From: (b)(6)
To: Murphy, Emmett
Cc: Androsco, Isaac
Subject: SONGS SG Update
Date: Tuesday, February 21, 2012 4:25:35 PM

From: (b)(6)
To: Anchondo, Isaac
Cc: Johnson, Andrew (b)(6); Murphy, Emmett (b)(6); Kulesa, Gloria; Warnick, Greg; Werner, Greg; Reynolds, John; Karwowski, Kenneth (b)(6); Markley, Michael; (b)(6); Hall, Randy (b)(6); Lantz, Ryan
Subject: RE: Agenda for SONGS 2/24 SG phone call
Date: Friday, February 24, 2012 9:48:38 AM

Attached are some preliminary responses from SCE regarding some of the NRC questions asked in the previous call on 2/6.

Figure 2-4: SONGS-2&3 AVB Retainer Bar General Arrangement (overhead view)

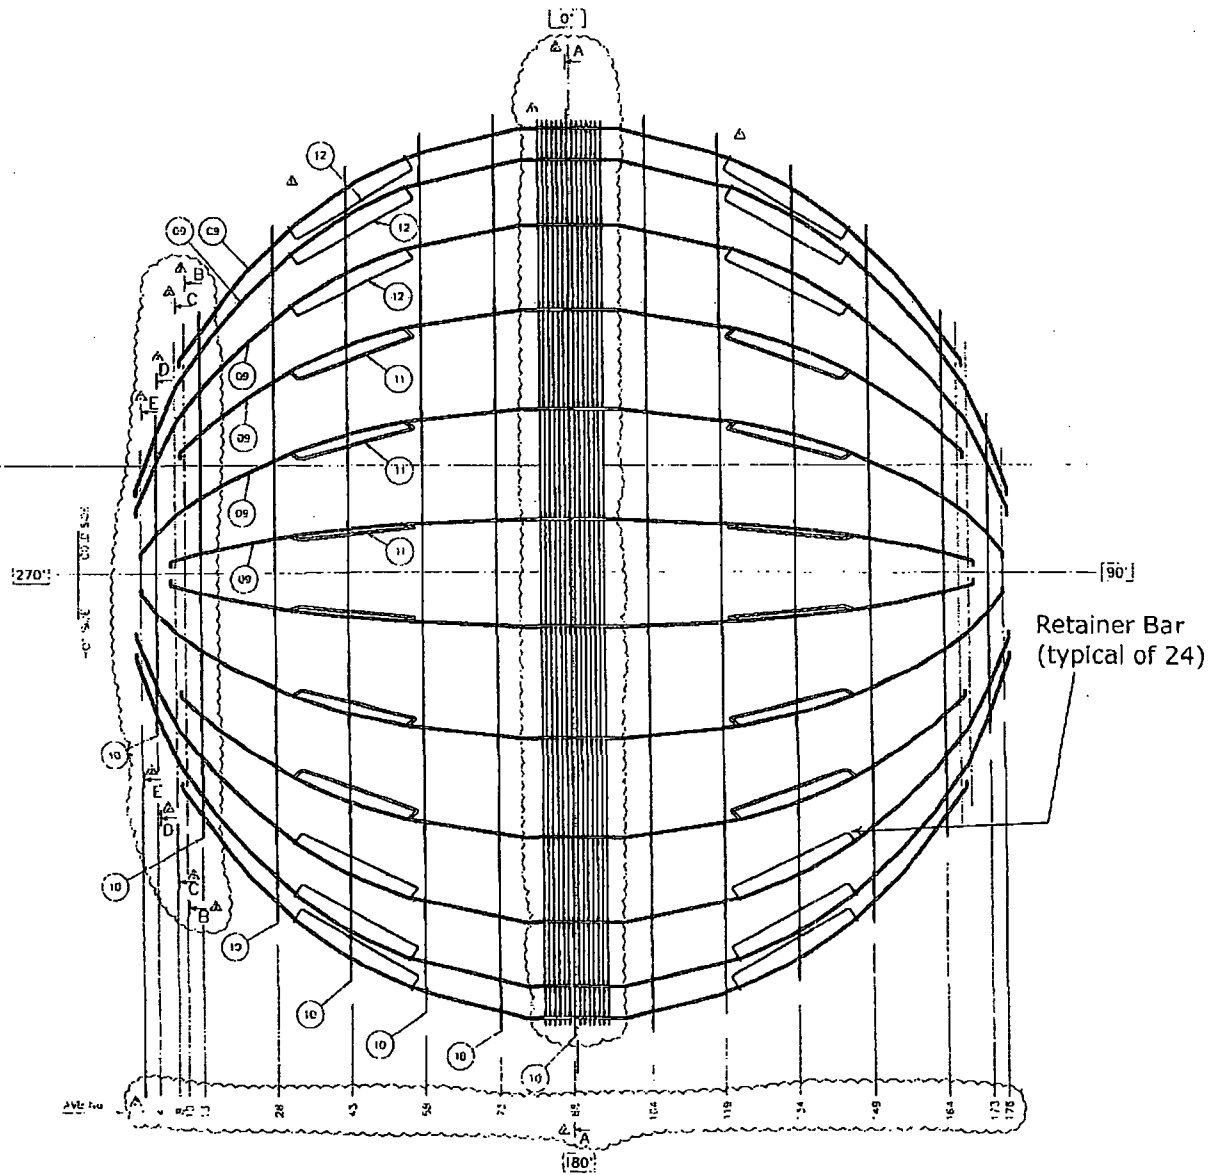
1. Provide sketches or drawings of the Anti Vibration Bar, Retaining Bar and the Retainer Bar.

Figure 7-2: Structural and Condition Monitoring Limit Curves for Wall Thinning at 820 psia Secondary Pressure

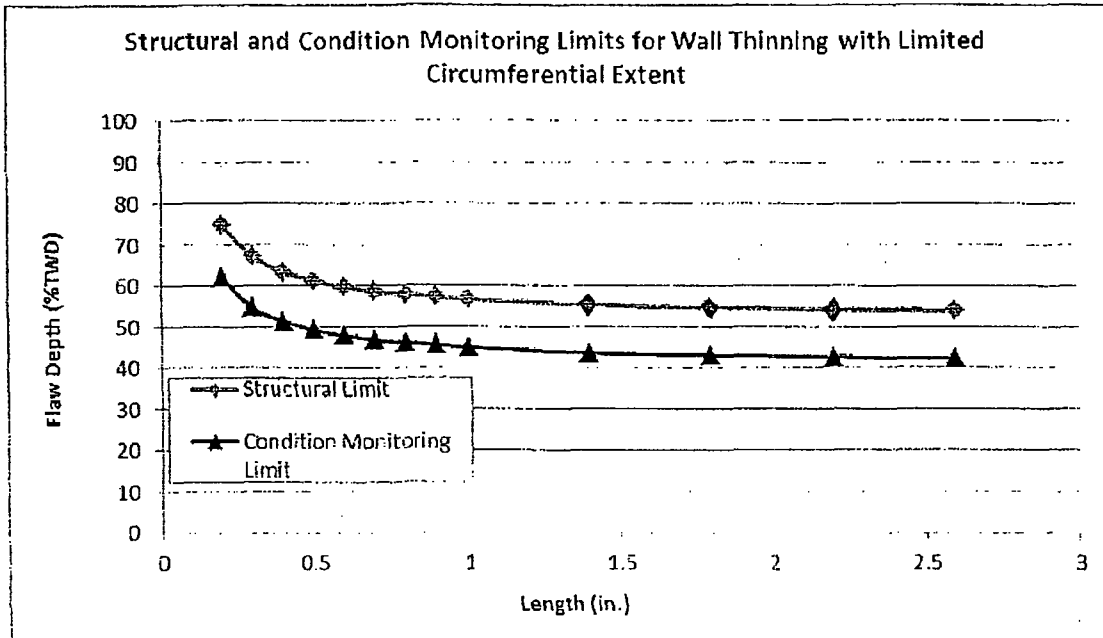
3. Provide condition monitoring structural limit curves.

AVB and TSP Wear +Point™ Depth vs Bobbin Depth

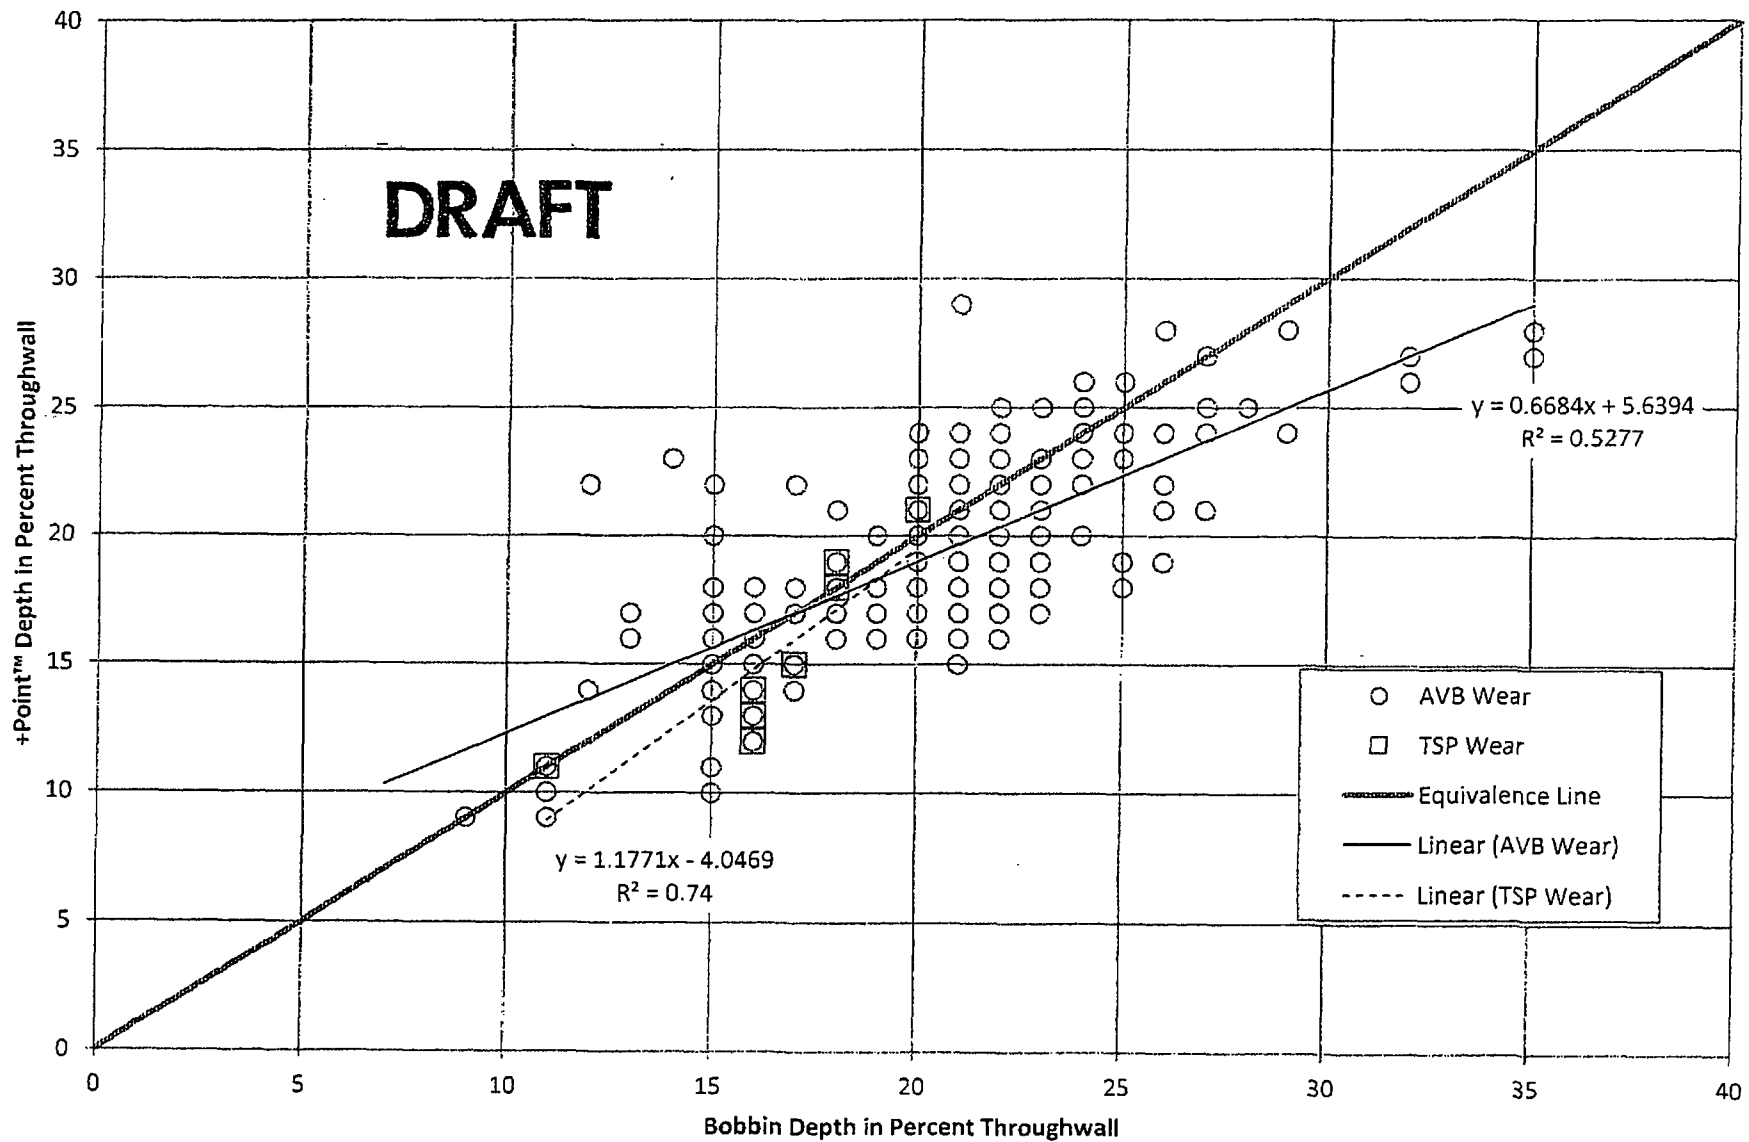
4. Provide info on the consistency between the tube wear results from the Bobbin ECT and the Rotating Probe results.
